UNIVERSITY OF FLORIDA
TRAINING REACTOR
LICENSE NO. R-56
DOCKET NO. 50-83

APPLICATION FOR CONVERSION FROM
HIGH-ENRICHED TO LOW-ENRICHED
URANIUM FUEL

Amendment 25
UFTR Technical Specifications

UNIVERSITY OF FLORIDA TRAINING REACTOR
FACILITY LICENSE: R-56, DOCKET NO. 50-83
REQUEST FOR CHANGE IN TECHNICAL SPECIFICATIONS
APPROVING HEU TO LEU CONVERSION

Figure 4-3 HEU Fuel Bundle XY Cut

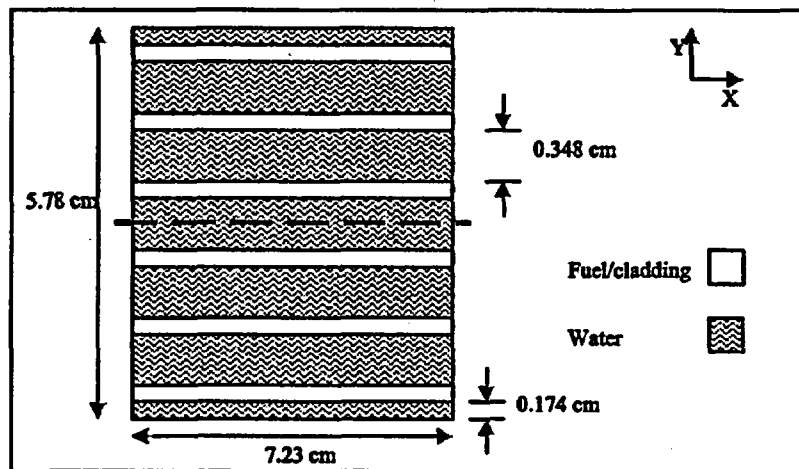
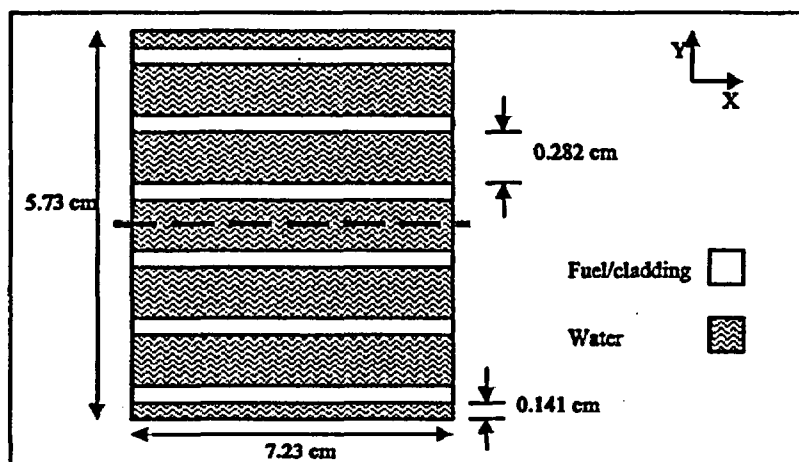
Fourth, on page 15 of the Tech Specs, in Section 3.7, Fuel and Fuel Handling, paragraph (1), the description of fuel elements is changed from "fuel elements consisting of 11 plates each . . ." to "fuel elements consisting of 14 plates each . . ." This change is necessitated by the basic LEU fuel assembly design selected for the conversion as described in Section 4 of *Attachment II* for the LEU fuel.

Each HEU fuel bundle is composed of 11 fuel plates. A water gap of 0.348 cm is provided between the fuel plates for coolant flow as illustrated in Figure 4-3.

The LEU fuel bundles are composed of 14 fuel plates with a water gap of 0.282 cm. Figure 4-4 depicts the layout of the fuel plates and water gaps in a LEU fuel bundle.

- (1) The maximum fuel loading shall consist of 24 full fuel elements consisting of 14 plates each containing enriched uranium and clad with high purity aluminum.
